UNITED STATES PATENT AND TRADEMARK OFFICE

10/711,326

Office Action Summary	Application No. 10/711,326	Applicant(s) NAKANO ET AL.	
	Examiner THOMAS W. IRVIN	Art Unit 3657

DETAILED ACTION

Figs. 1 and 2 (US Patent 3,168,836)

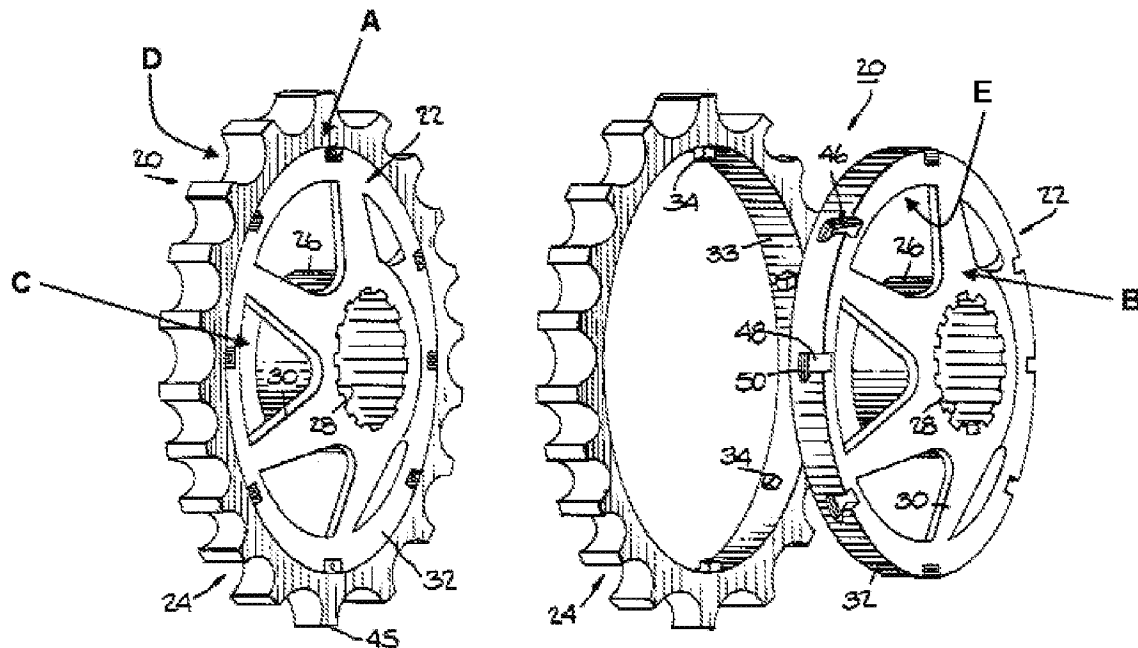
In Re claim 1, with reference to Figs. 1 and 2 shown above, Militana discloses a sprocket, wherein the sprocket comprises: a sprocket body (20); a plurality of teeth (45) extending radially outwardly from the sprocket body; a spline (28) extending radially inwardly from the sprocket body; wherein the spline includes a radially outer surface (26) facing radially outwardly; and wherein the radially outer surface of the spline faces a radially inner surface (E) of the sprocket body.

In Re claim 5, the sprocket body has a side wall that includes a first side wall portion (A) and a second side wall portion (B), wherein the plurality of teeth extend radially outwardly from the first side wall portion, and wherein the second side wall portion is laterally offset from the first side wall portion.

In Re claim 6, the second side wall portion overlaps the outer surface (26) when viewed in a direction parallel to the rotational axis.

In Re claim 9, the spline extends from the second side wall portion and terminates at a free end (C), and the free end is spaced apart from a first side wall (D) of the first side wall portion (A) that faces in a same direction as the free end.

In Re claim 13, with reference to Figs. 1 and 2 shown above, Militana discloses a bicycle sprocket, wherein the sprocket comprises: a sprocket body (20); a plurality of

teeth (45) extending radially outwardly from the sprocket body; a spline (28) extending radially inwardly from the sprocket body, wherein the spline has a root portion (30) and a radially inner portion (26), wherein the root portion extends radially inwardly of the sprocket body and has a side wall (B) facing in a rotational direction, and wherein the radially inner portion extends radially inwardly of the root portion and has a side wall (C) facing in the rotational direction; and wherein a thickness of the radially inner portion of the spline in a direction parallel to the rotational axis is greater than a thickness of the root portion of the spline in a direction of the rotational axis.
